RE: Lot 3 Block 4 Unit 19 Volcano Cliffs Subd.

6548 Azor Ln NW

RE: Lot 3 Block 4 Unit 19 Volcano Cliffs 6548 Azor Lane NW Grading and Drainage Plan Engineers Stamp Date 7/9/15 (D10D003T3)

Based upon the information provided in your submittal received 7/9/15, this plan cannot be approved for Grading Permit and Building Permit until the following comments are addressed.

GRADING & DRAINAGE PLAN 6548 Azor Lane, NW LOT 3, BLOCK 4, UNIT 19 VCS

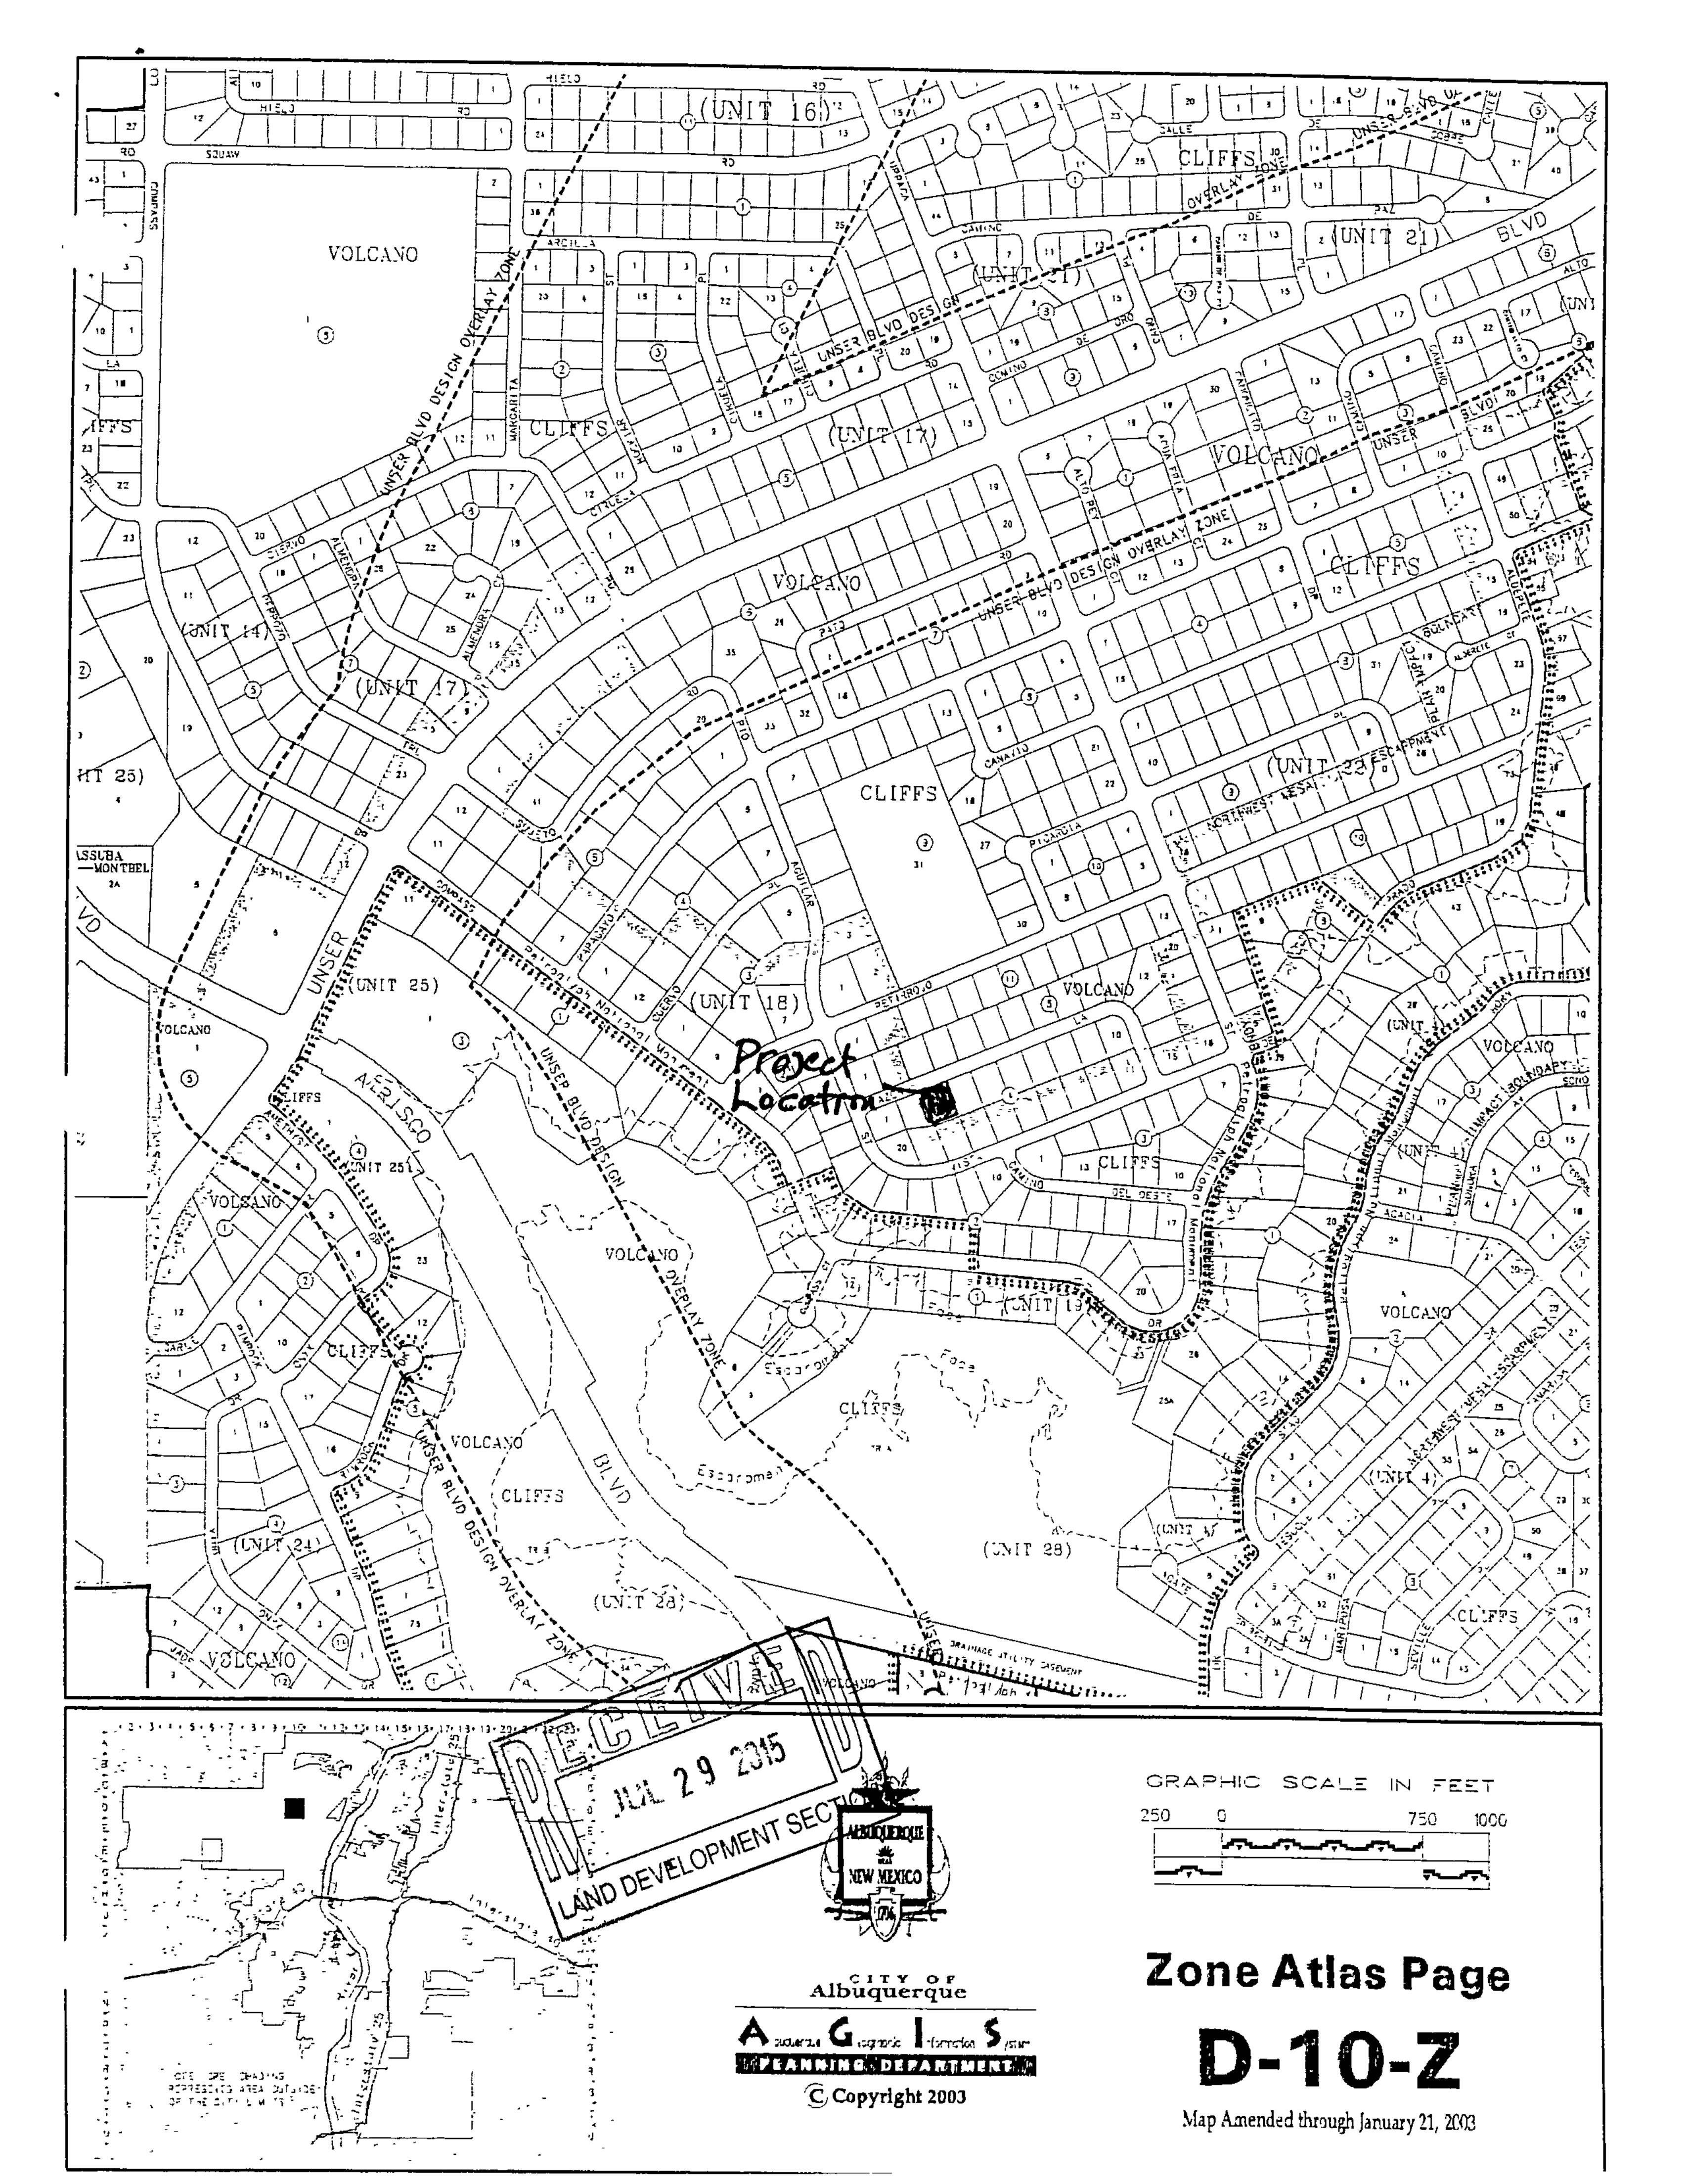
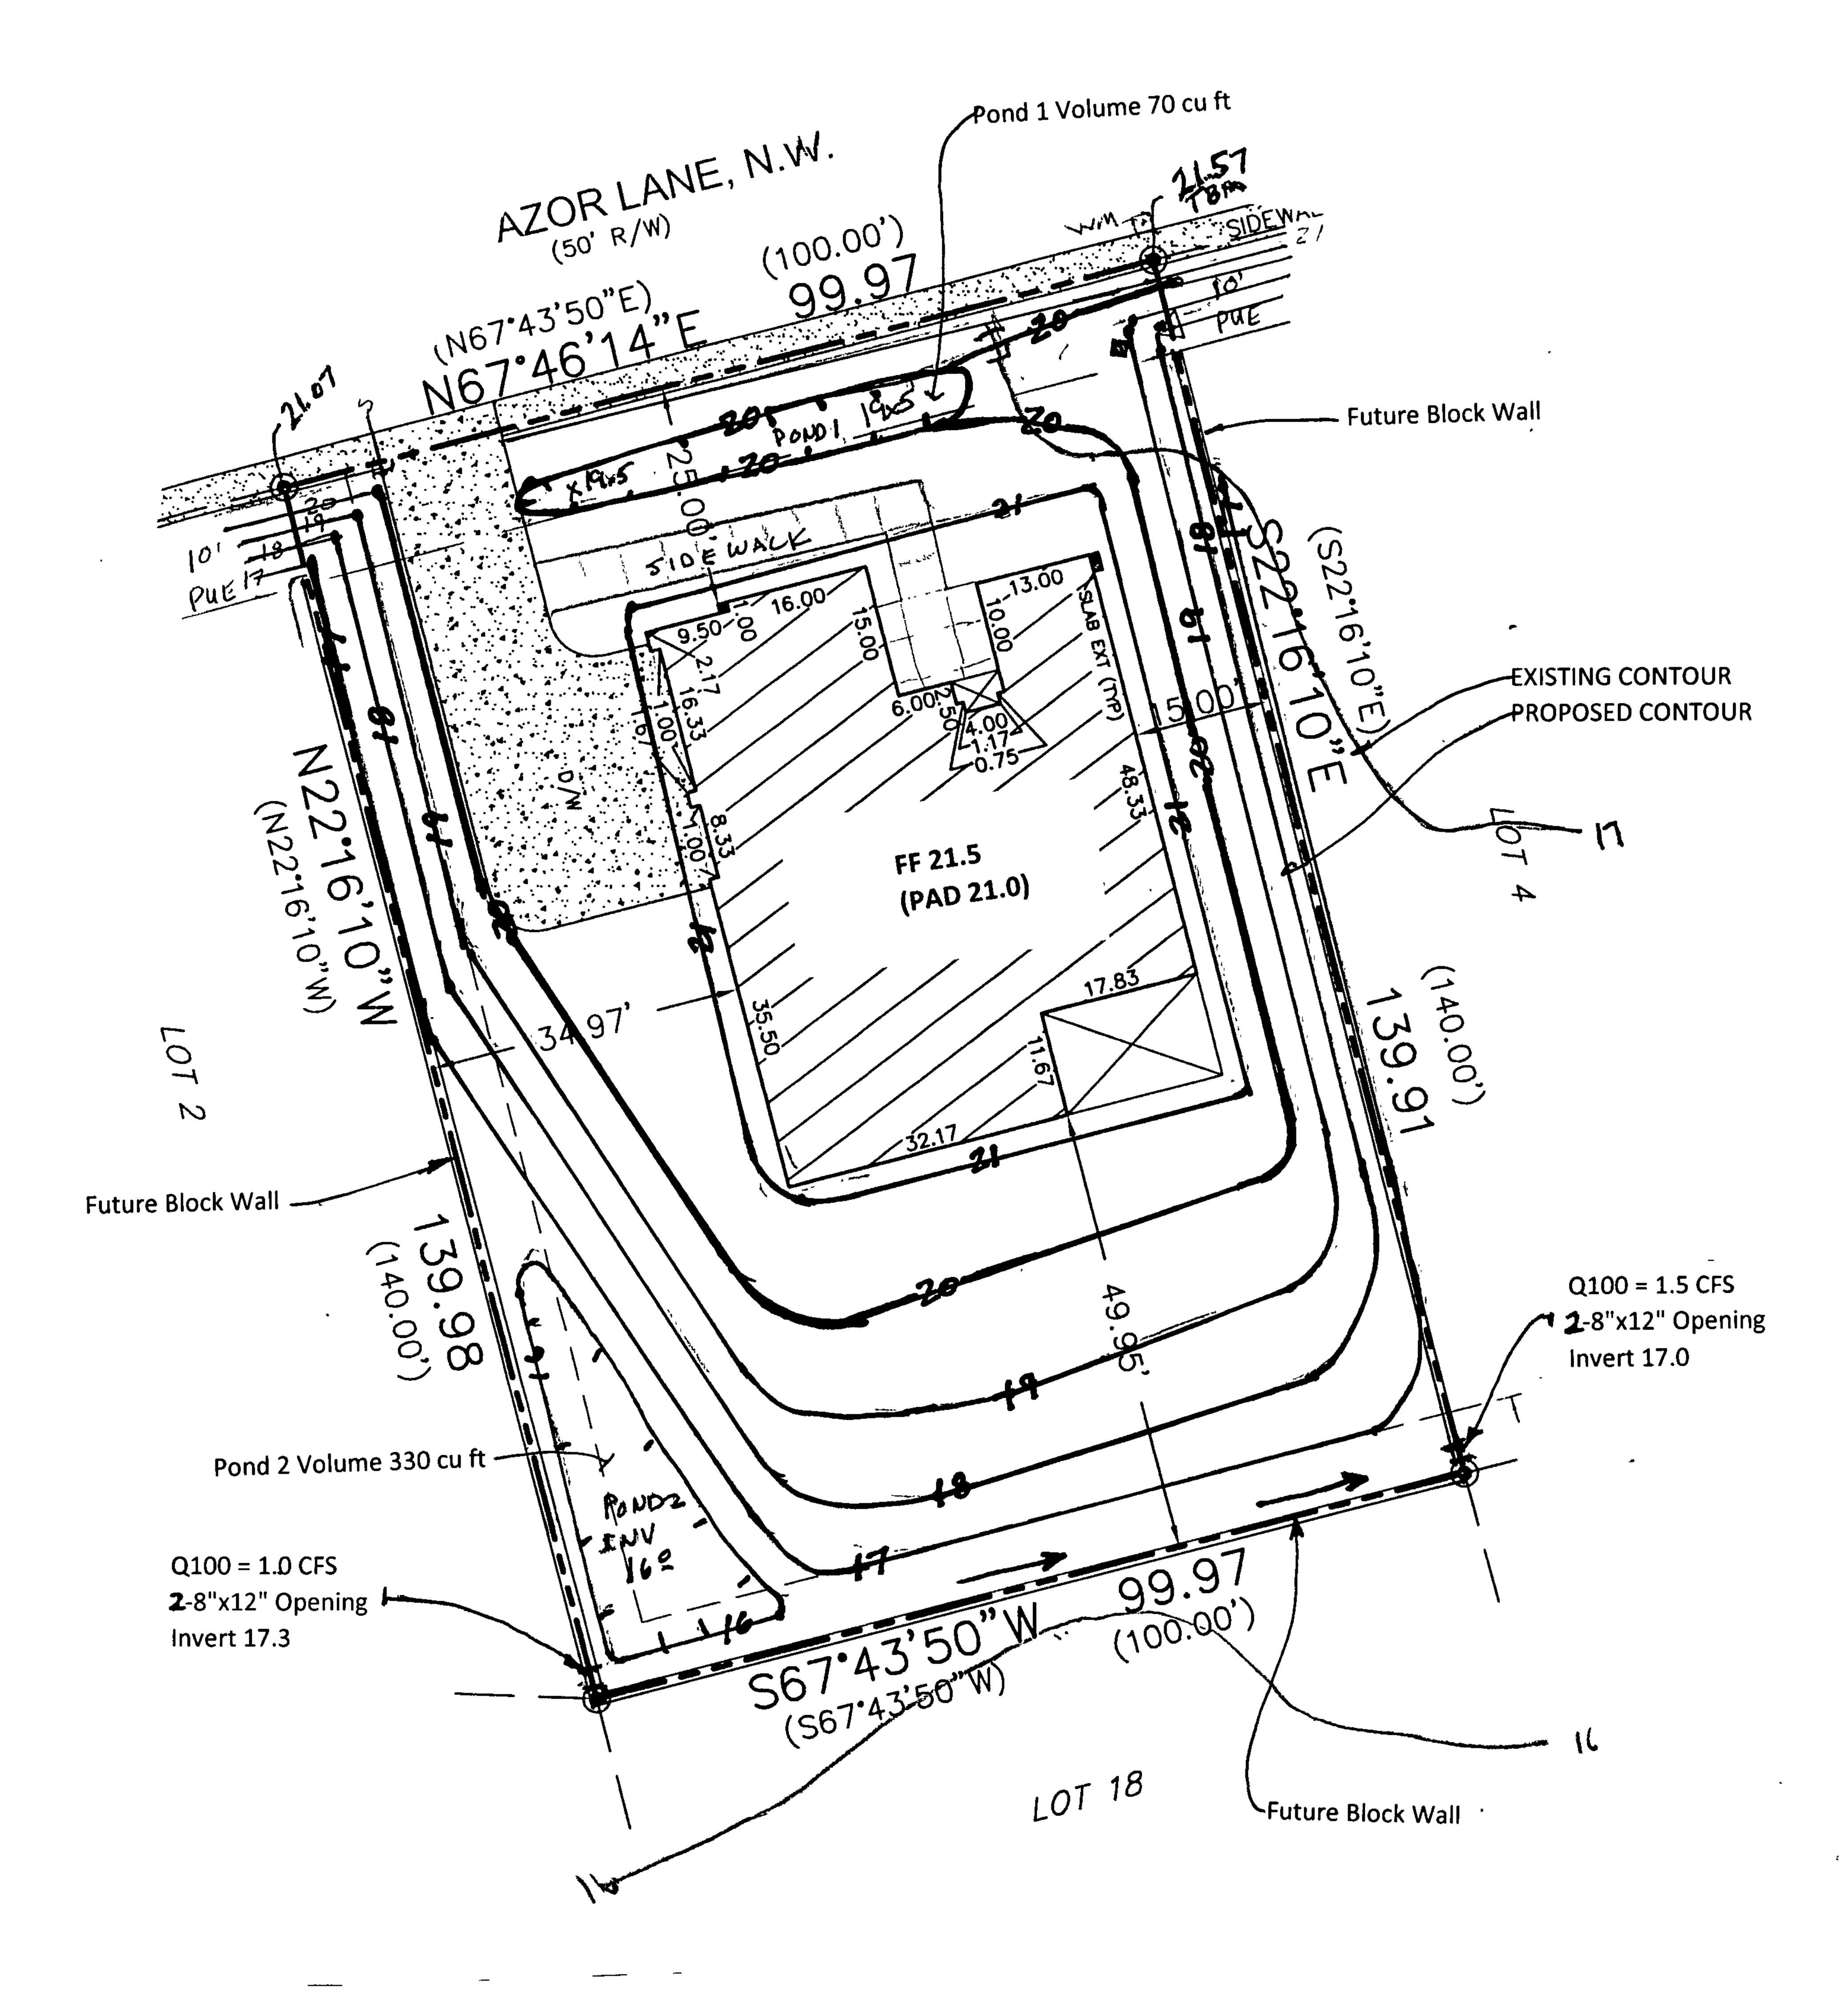
Provide flows for this property which exit out to Azor Street.

Remove block openings.

Provide swales from rear yard to front yard both sides of structure.

Based upon the information provided in your submittal received 7/29/2015, this plan is approved for Grading Permit and Building Permit.
